SUBJECT: SOUTH TEXAS PROJECT, UNITS 1 AND 2 - AMENDMENT NOS. 61
AND 50 TO FACILITY OPERATING LICENSE NOS. NPF-76 AND NPF-80
(TAC NOS. M86688 AND M86689)

HOUSTON LIGHTING & POWER COMPANY
CITY PUBLIC SERVICE BOARD OF SAN ANTONIO
CENTRAL POWER AND LIGHT COMPANY
CITY OF AUSTIN, TEXAS
DOCKET NO. 50-498
SOUTH TEXAS PROJECT, UNIT 1
AMENDMENT TO FACILITY OPERATING LICENSE

HOUSTON LIGHTING & POWER COMPANY
CITY PUBLIC SERVICE BOARD OF SAN ANTONIO
CENTRAL POWER AND LIGHT COMPANY
CITY OF AUSTIN, TEXAS
DOCKET NO. 50-499
SOUTH TEXAS PROJECT, UNIT 2
AMENDMENT TO FACILITY OPERATING LICENSE

FIGURE 2.1-1

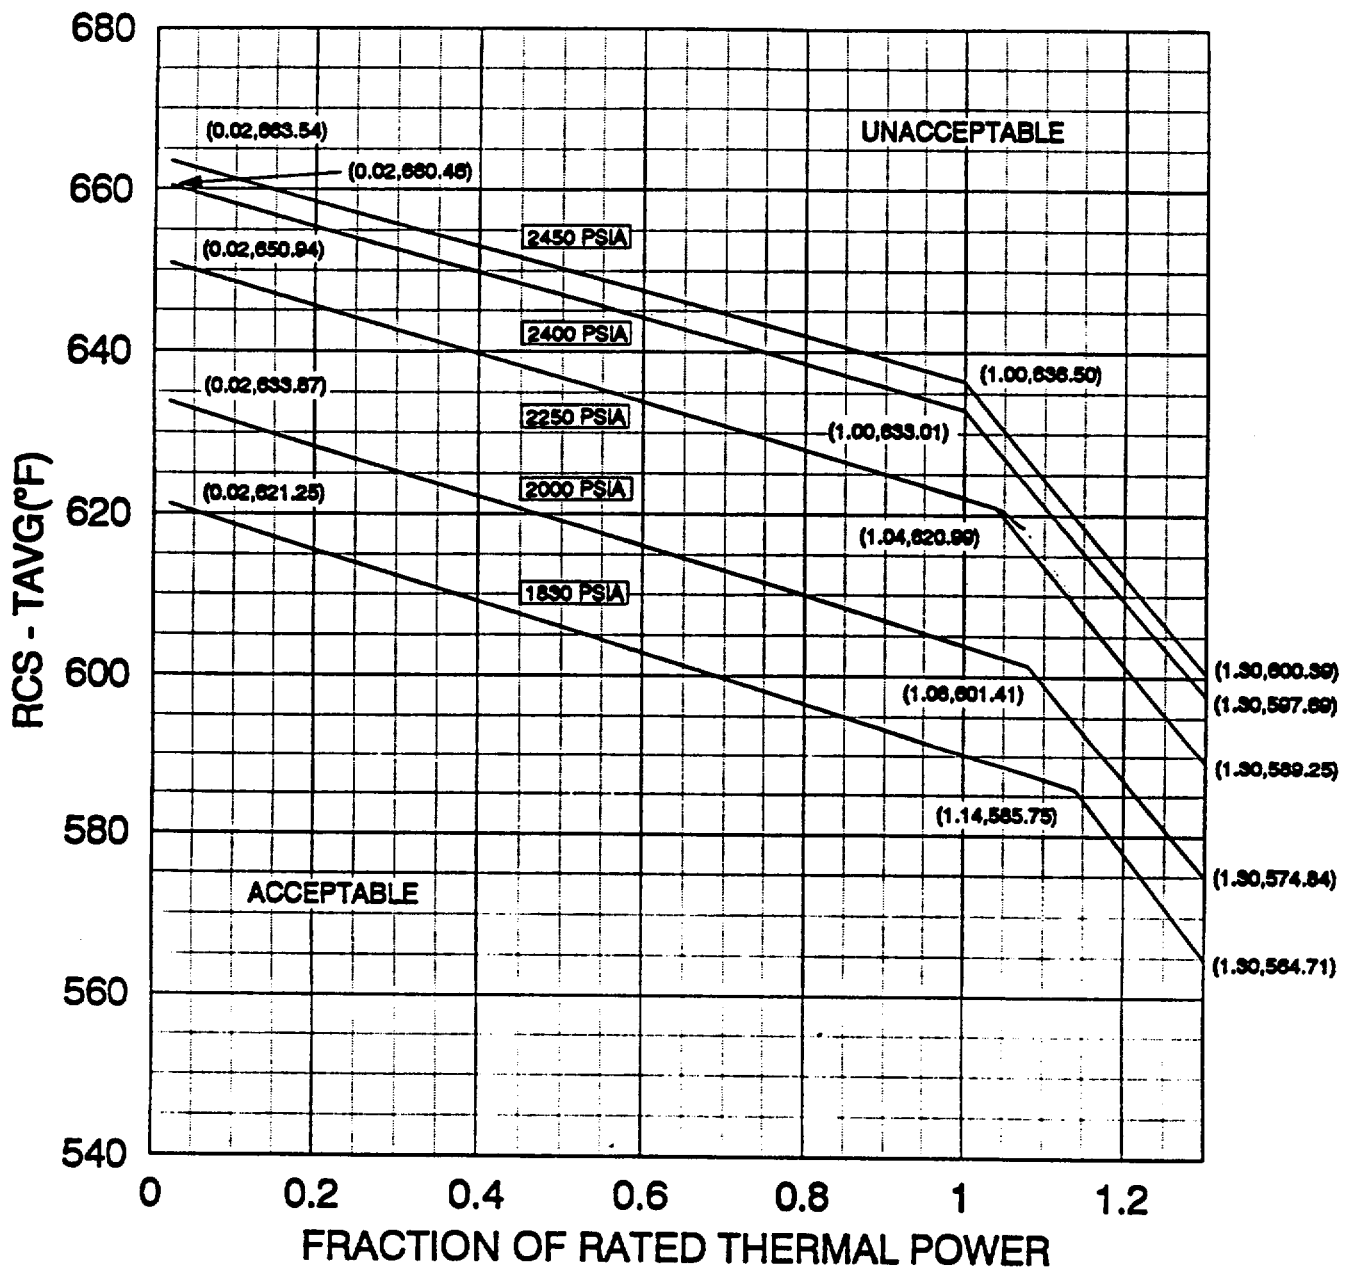
(1) Figure 2.1-1, Reactor Core Safety Limits

The figure was revised to reflect the change of the limiting safety limits on the combination of the reactor thermal power, pressurizer pressure, and the highest operating loop coolant temperature. The changes reflect the DNB margin gained through use of the VANTAGE 5H IFM grid feature, the use of the improved THINC IV code, the WRB-1 DNB correlation, and RTDP. The limits are also reflected in the revised LOCA analyses for STP. Therefore, the limits given in TS Figure 2.1-1 are acceptable.

FIGURE 3.1-1

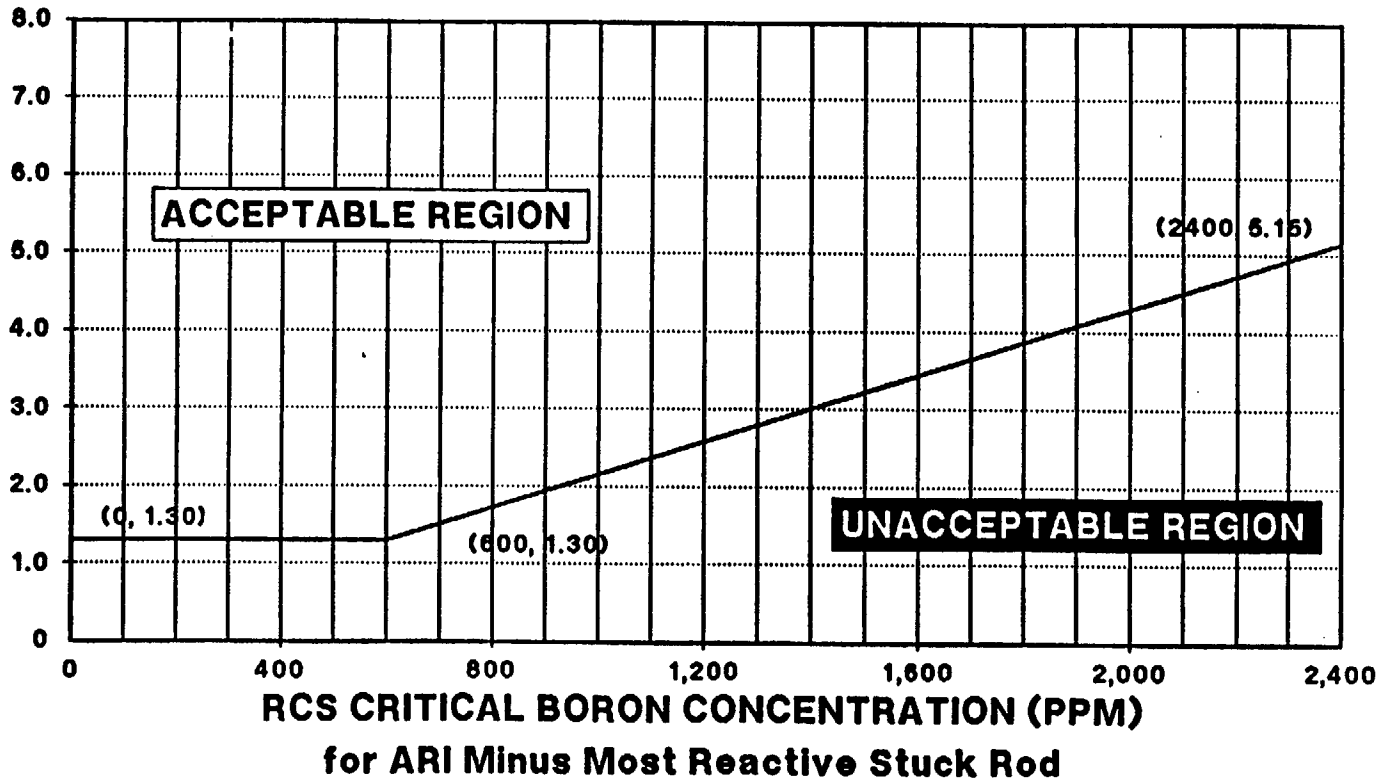
The licensee has proposed to reduce the shutdown margin specified in TS 3.1.1.1/Figure 3.1-1 (covering operating Modes 1-4) and 3.1.1.2/Figure 3.1-2 (Mode 5) from 1.75 delta-K/K to 1.3 percent delta-K/K. These changes are supported by the results of affected analyses: main steam system depressurization; steamline break; feedline break; boron dilution events; and, post-LOCA shutdown. The results of these analyses indicate that design and

acceptance criteria will continue to be met assuming the reduced margin. The staff finds the proposed reduced shutdown margin is acceptable. TS Bases 3/4.1.1 and 3/4.1.2 have been revised to reflect the reduced shutdown margin, and are acceptable.

Figure 3.1-2a
MTC versus Power Level

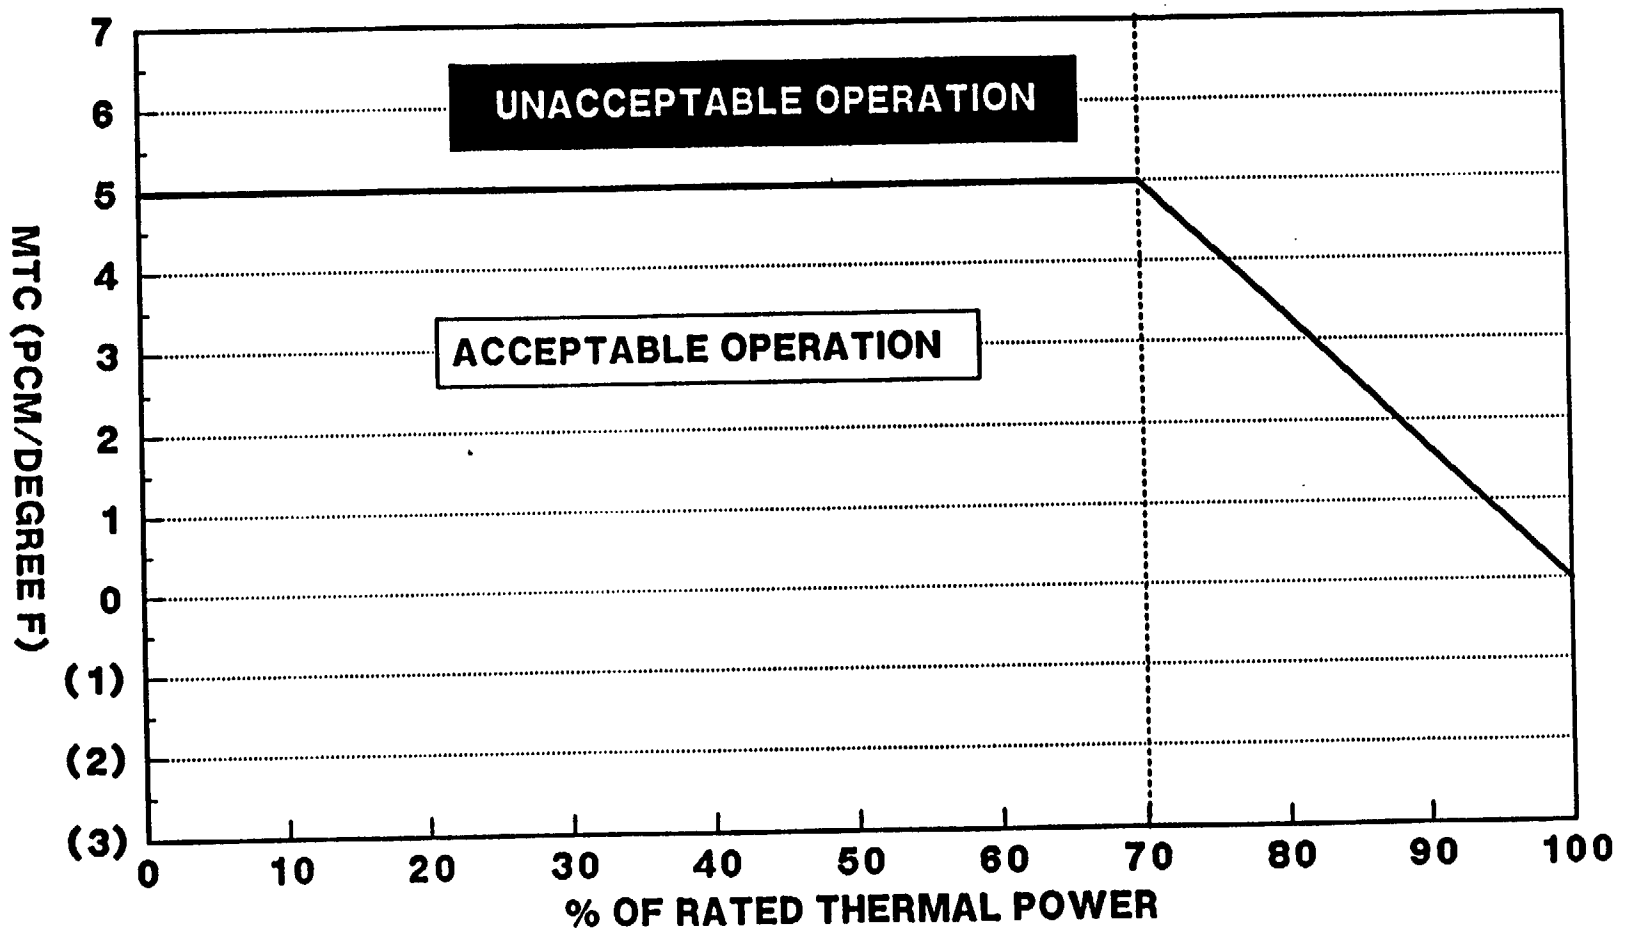
(3) Figure 3.1.2a, Moderator Temperature Coefficient

The licensee has proposed that the moderator temperature coefficient (MTC) limit specified in the STP TS 3.1.1.2/Figure 3.1.2a be revised for future core designs to permit a positive MTC. Several related safety analyses included in the submittal assumed a MTC of +5 pcm/F. The locked rotor analysis assumed a more limiting MTC of +5 pcm/F for powers up to 70 percent of rated thermal power and a linear ramp value from 70 percent power to 0 pcm/F at 100 percent power. The licensee proposes to incorporate the ramped MTC function assumed in the locked rotor analysis into the STP TS. The licensee is not proposing to implement this MTC revision at this time and the COLR MTC value remains 0 pcm/F. The staff finds the TS limit change acceptable because it is supported by related analyses.

Figure 5.6-7

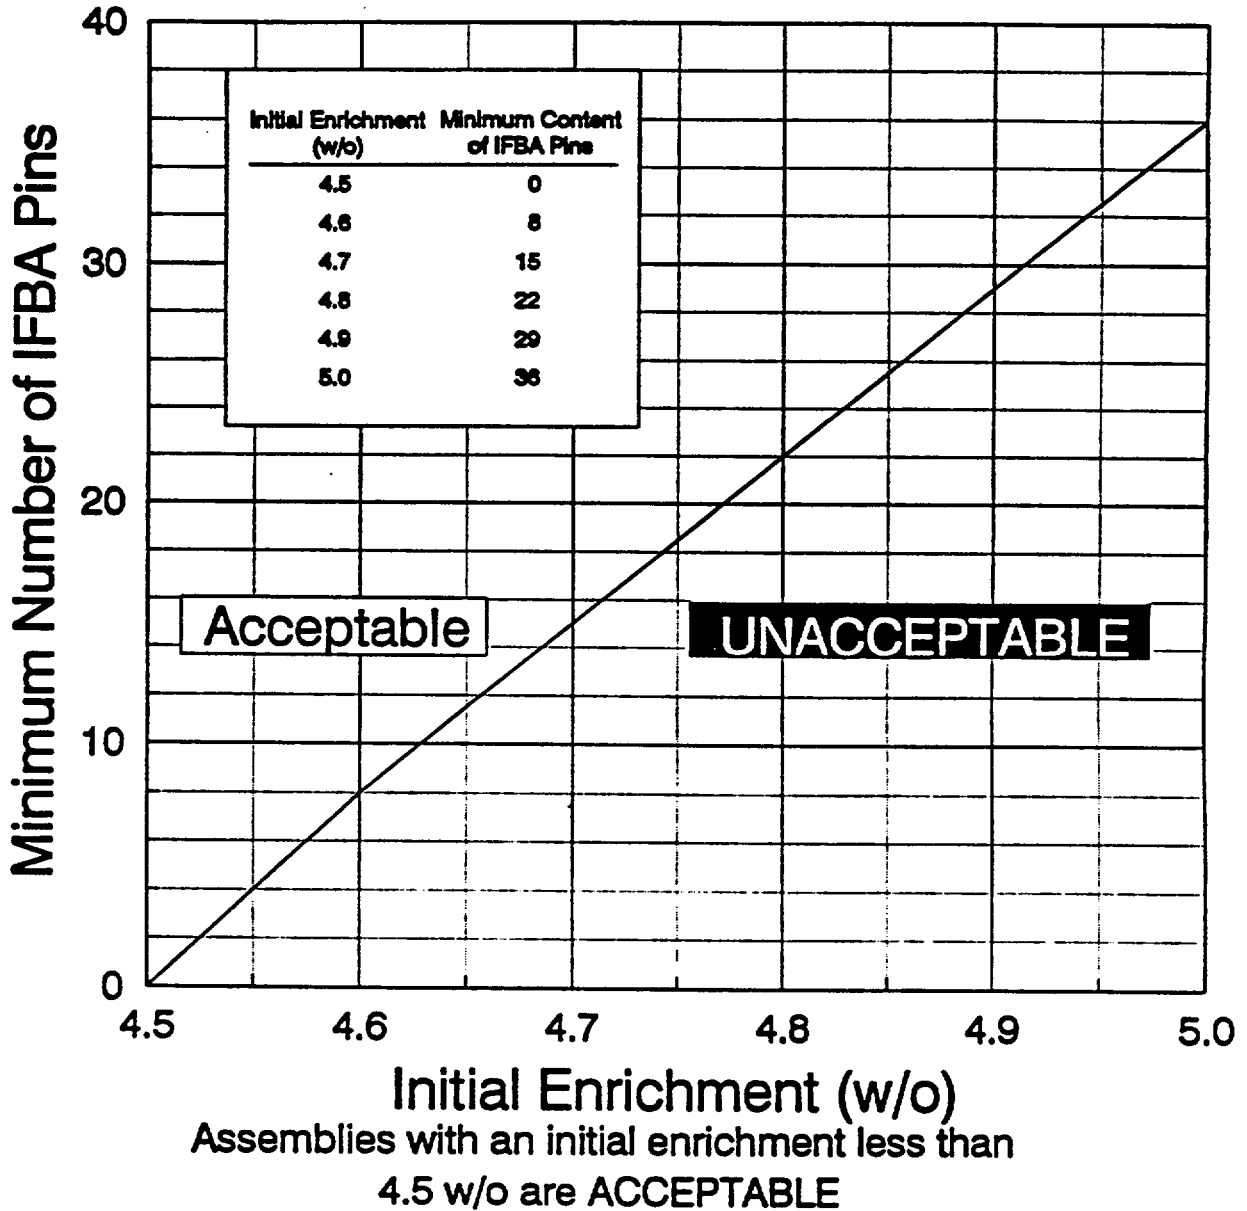
TS 5.6.1.7, TS 5.6.1.8, and Figure 5.6-7 are added to describe the new fuel storage and in-containment storage rack requirements. The staff has concluded that the acceptance criteria are met, and storage provisions are acceptable for STP fresh and in-containment fuel storage racks for the storage of all Westinghouse 17x17 fuel assemblies as discussed in Section 2.2. The proposed change is acceptable.
